Service Bulletin No: 32-029**Ref No: 429****Modification No: EC-19-0639****ATA Chapter: 32****LANDING GEAR - NOSE LANDING GEAR - FORK ASSEMBLY - INSPECTION AND REPLACEMENT****1. Planning Information****A. Effectivity**

All PC-12 Nose Landing Gear (NLG) cylinder pipe P/N 532.20.12.145 with Serial Numbers SI-0871 thru 0894 and SI-0897 thru 0899 installed as part of the NLG fork assembly P/N 532.20.12.112 and/or NLG strut assembly P/N 532.20.12.044 on PC-12, PC-12/45, PC-12/47 and PC-12/47E Series aircraft and/or held as spares.

Nose Landing Gear Fork Assembly - Inspection
Figure 1

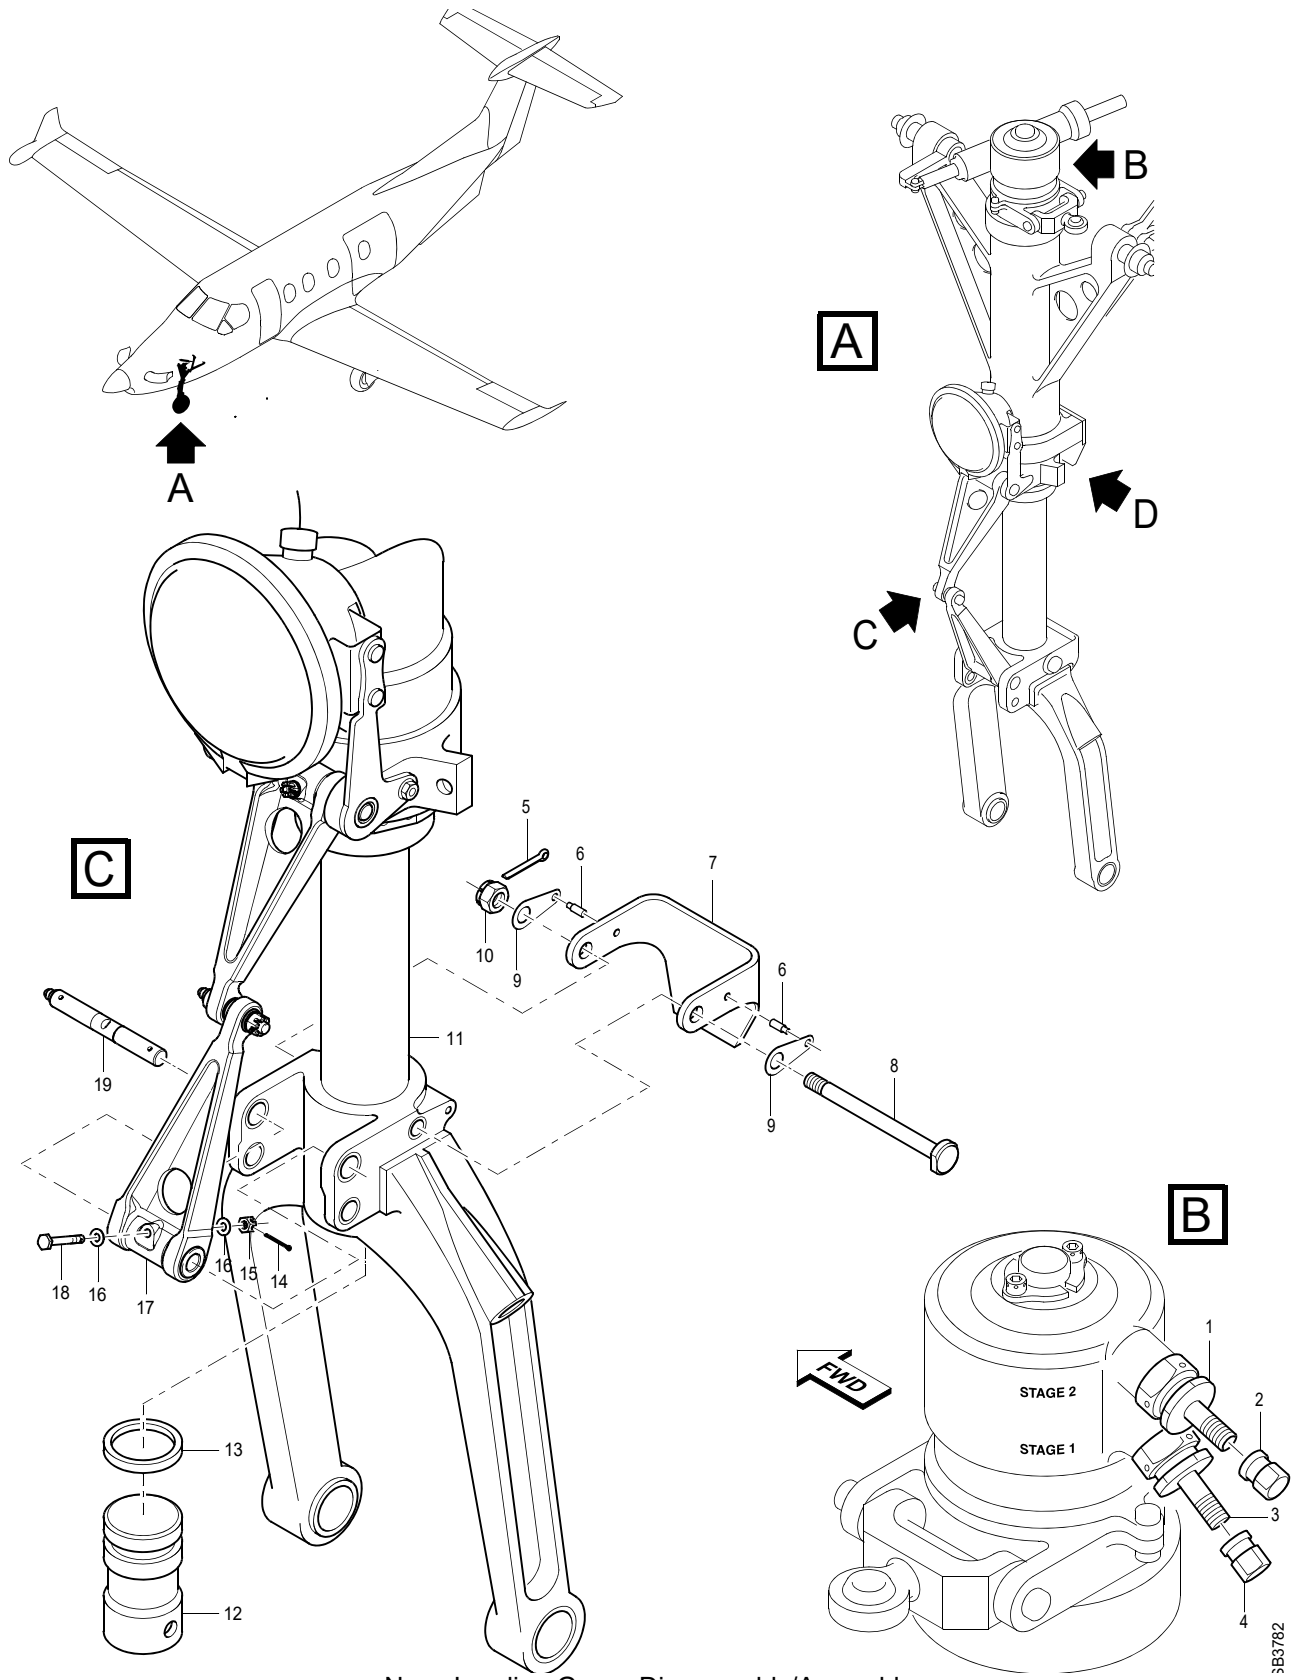
(1) Use a lint-free cloth (Mat. No. P02-041) and white spirit (Mat. No. P01-008) to clean the NLG sliding tube at the NLG fork interface, refer to "Figure 1" on page 14 for the area to be inspected.

(2) Inspect the NLG sliding tube at the NLG fork interface for corrosion. If necessary, use a magnifying glass to do the inspection.

(3) If you find corrosion, or see untreated material, replace the fork assembly, refer to para 3.C, 3.D and 3.E.

Nose Landing Gear - Disassembly/Assembly
Figure 2 Sheet 1

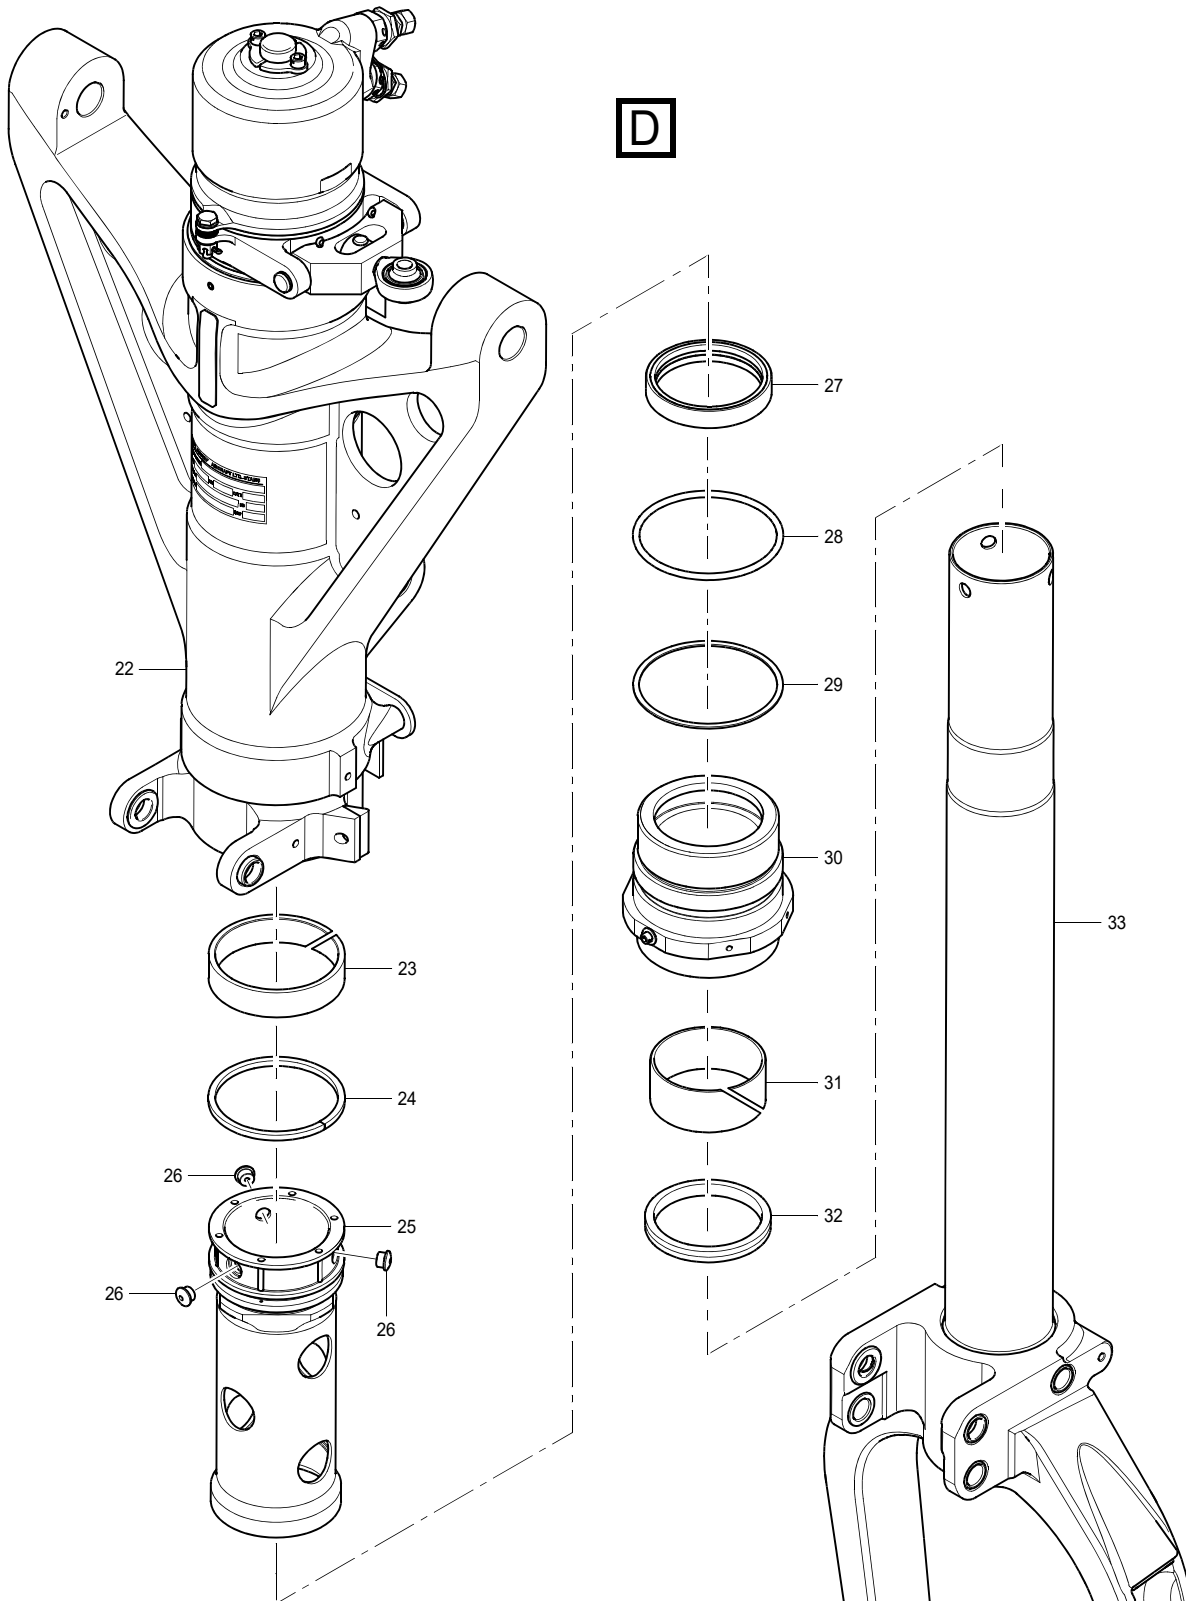
Refer to "Figure 2 Sheet 1" on page 15 and "Figure 2 Sheet 2" on page 16.

- (11) Carefully remove the fork assembly (33) together with the barrel nut (30) and guide pipe assembly (25) from the steering tube (22).
- (12) Remove the guide pipe (25):
 - (a) Remove the guide ring (23) from the guide pipe (25).
 - (b) Use the pin extractor (P/N 513.32.12.061) to remove the three pins (26), then remove the guide pipe (25) from the fork assembly (33).
- (13) Remove the barrel nut (30) from the fork assembly (33).
- (14) Disassemble the barrel nut (30):
 - (a) Remove and discard the preformed packing (28) and packing retainer (29) from the barrel nut (30).
 - (b) Remove and discard the scraper ring (32) from the barrel nut (30).
 - (c) Remove and discard the sealing ring (27) (three pieces) from the barrel nut (30).

NOTE: The sealing ring has three parts, a T seal with a top and bottom sealing ring. The sealing rings have a contour and are installed with the contour pointing to the T seal.
 - (c) Install the packing retainer (29) and preformed packing (28) on the barrel nut (30).
 - (d) Apply a thin layer of grease (Mat. No. P04-028) to the inner side of the barrel nut (30).
 - (e) Carefully install the barrel nut (30) on the new fork assembly (33) (P/N 532.20.12.240).
- (2) Attach the guide tube (25) to the fork assembly (33):

- (a) Put the guide pipe (25) on the fork assembly (33) in the position where the holes in the guide pipe are aligned with the holes in the fork assembly.
 - (b) Use the pin extractor/insertion tool (P/N 513.32.12.061) and install the three pins (26) in the guide pipe (25) and fork assembly (33).
 - (c) Install the guide ring (23) on the guide pipe (25).
- (3) Put the rubber guide (P/N 513.32.12.063) into the steering tube (22).
- (4) Carefully put the fork assembly (33) together with the barrel nut (30) and the guide pipe assembly (25) into the steering tube (22). Remove the rubber guide.
- (5) Install the barrel nut (30):
